PROPOSED 18 MT WIDE ROAD

REVISIONS	DATE	REMARKS
SCALE :		
DRAWING TITLE	SITE PLAN	NORTH
NATURE OF DRAWING	SUBMISSION DRAWING	
PROJECT : PROPOSED SUBMISSION GROUP HOUSING PROJECT APARAMEYA ENCLAVE AT HASRUR NO.- 126, 126/1, 127/1, 127/1 & 127/2 AT VILLAGE NOOR MGAR ROUNGAR NOOR VILLAGE GHANZABAO.		
PROJECT CONSULTANTS : HOLISTIC URBAN INNOVATIONS PVT. LTD. PLANNING & ARCHITECTURE FIVE & NINE ACTIVITIES THE CONSULTANT TOWER-44/1, SEC-48, INDRA-2/1 30/1 Ph. - 0120-4272003, 204, FAX: 0120-4272005		
OWNER SIGN	MANISH KUMAR (A-44, Sector-48, Indira Nagar, New Delhi) the proprietor, A-44, Sector-48, Indira Nagar	
ARCHITECT SIGN		
IMPORTANT: 1. IN CASE OF ANY DISCREPANCY IN THE DRAWING, THIS OFFICE SHALL BE REFERRED TO FOR CLARIFICATION. 2. ALL DIMENSIONS ARE IN MILLIMETERS.

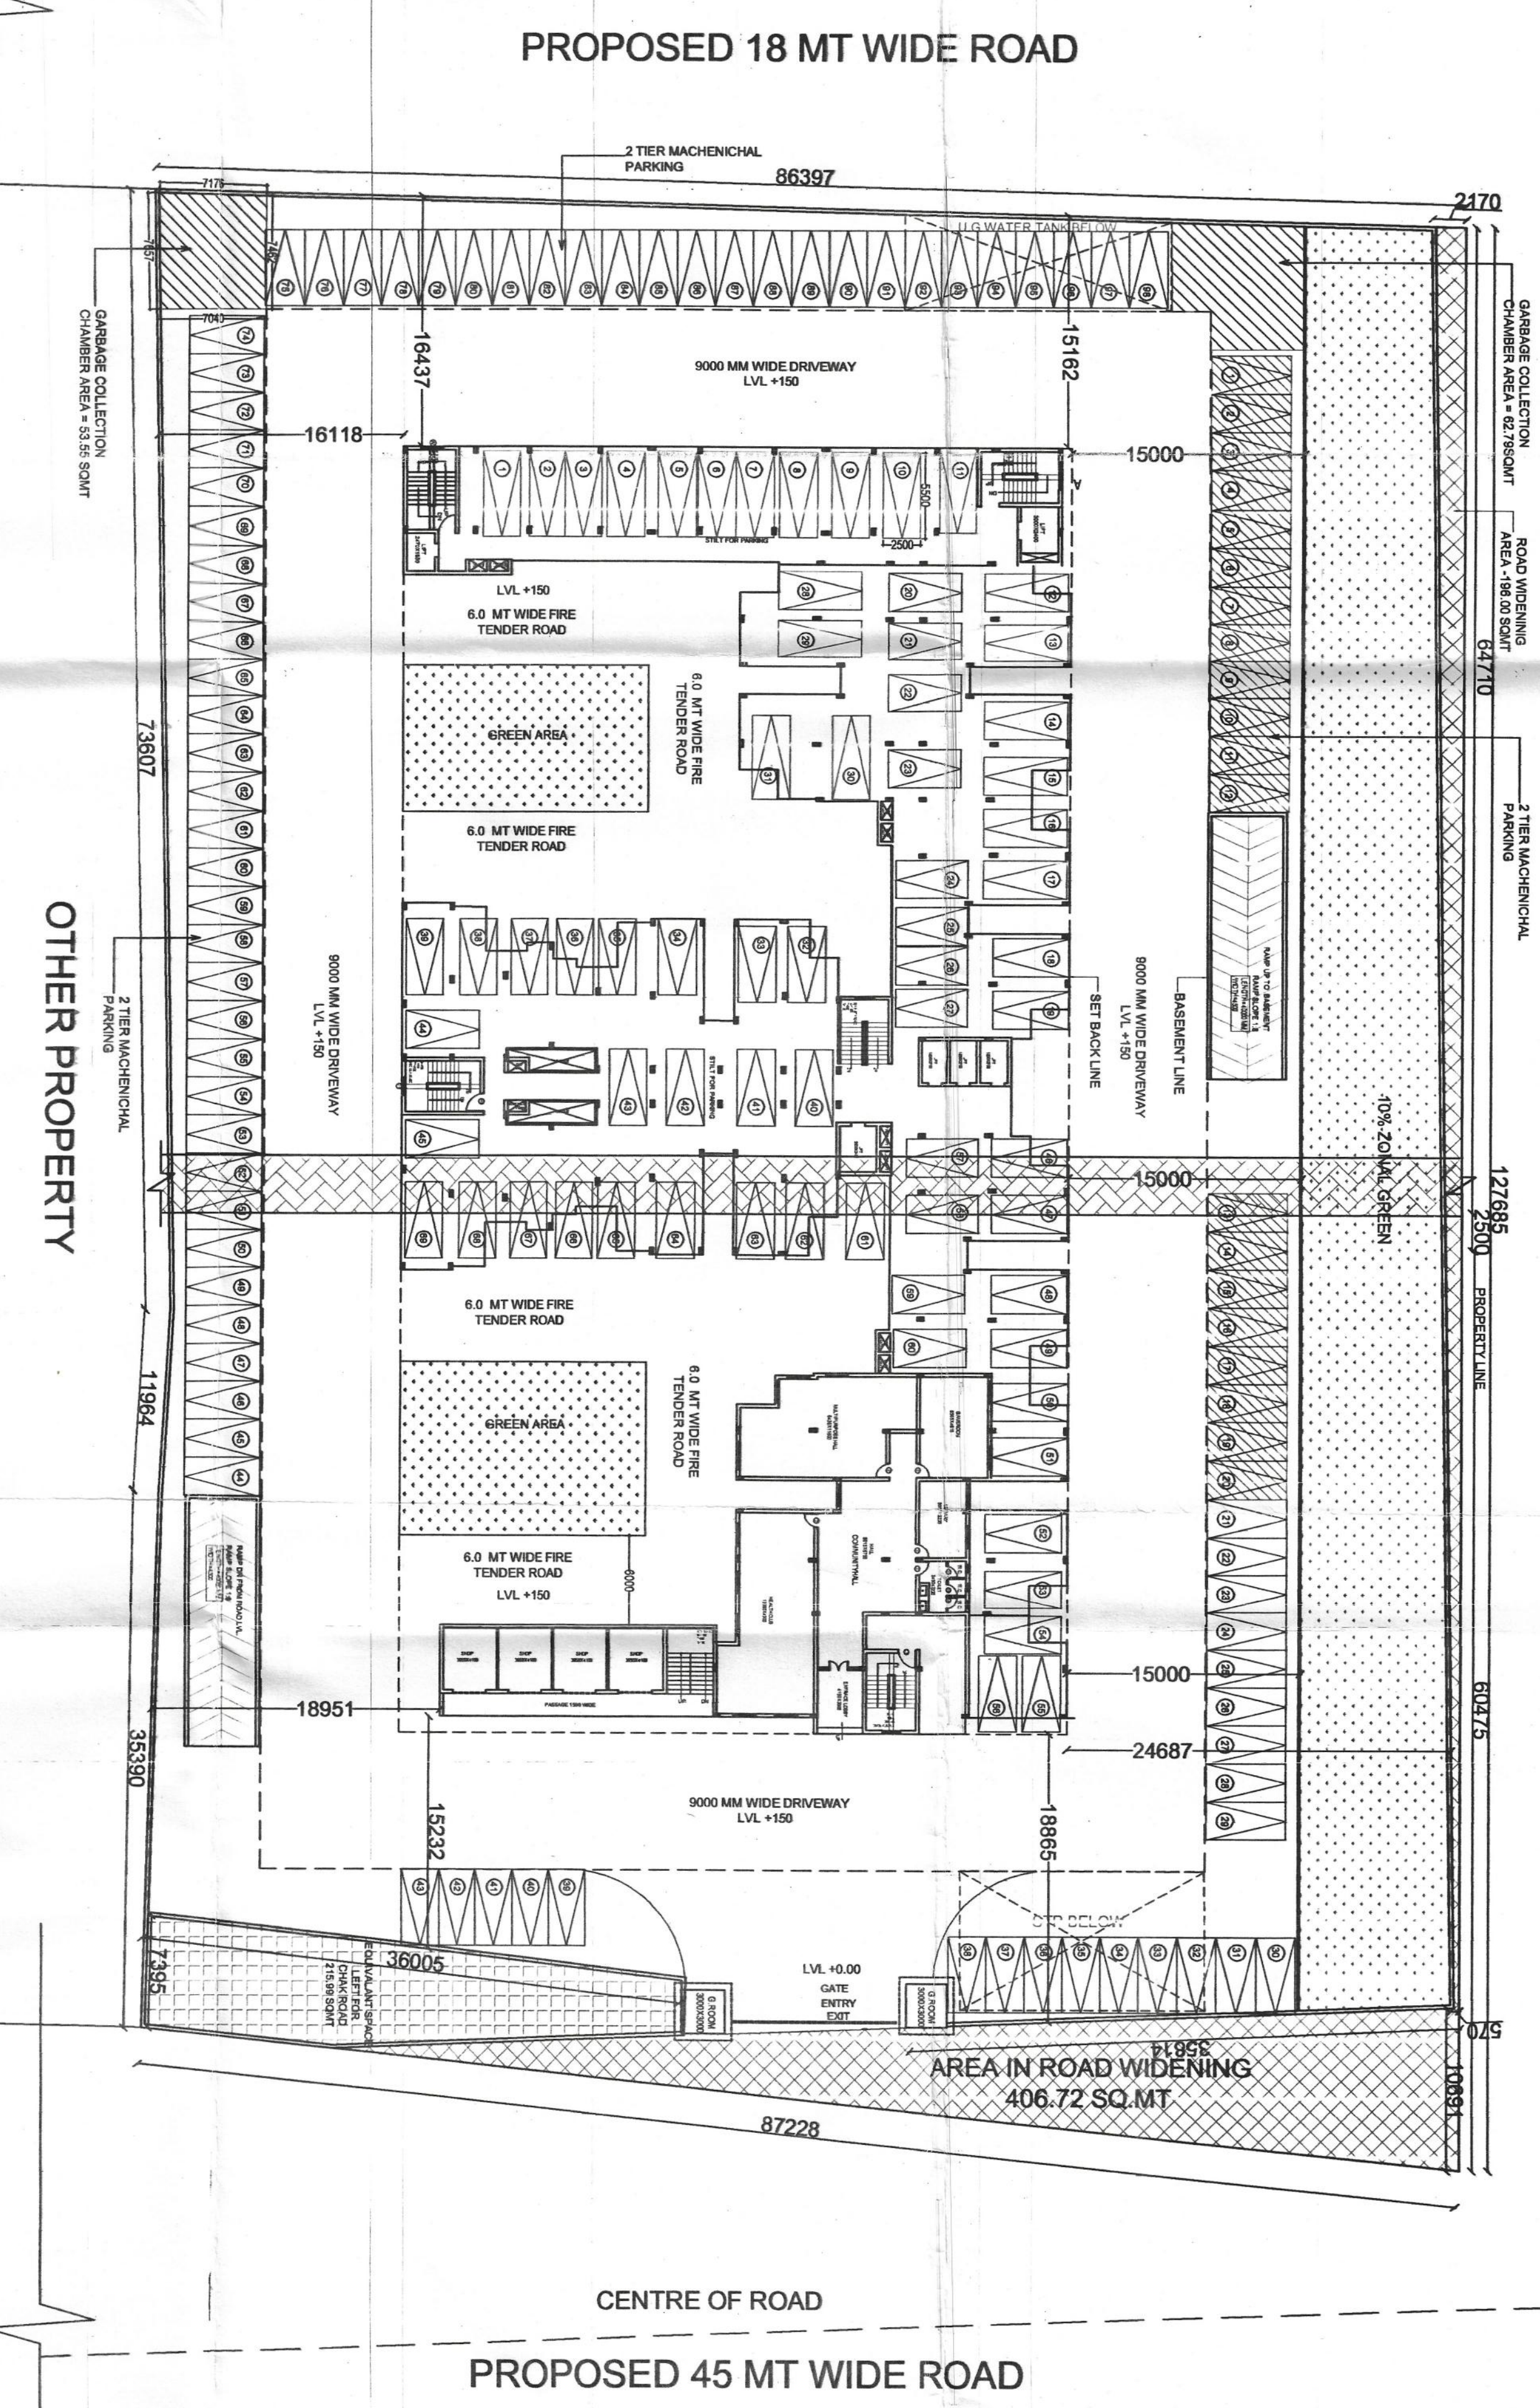
पर्यावरण को दृष्टि से राज्य वन निधि अधिनियम के अन्तर्गत कम से कम ~~40~~ ५० फीसद लगाना अनिवार्य है।
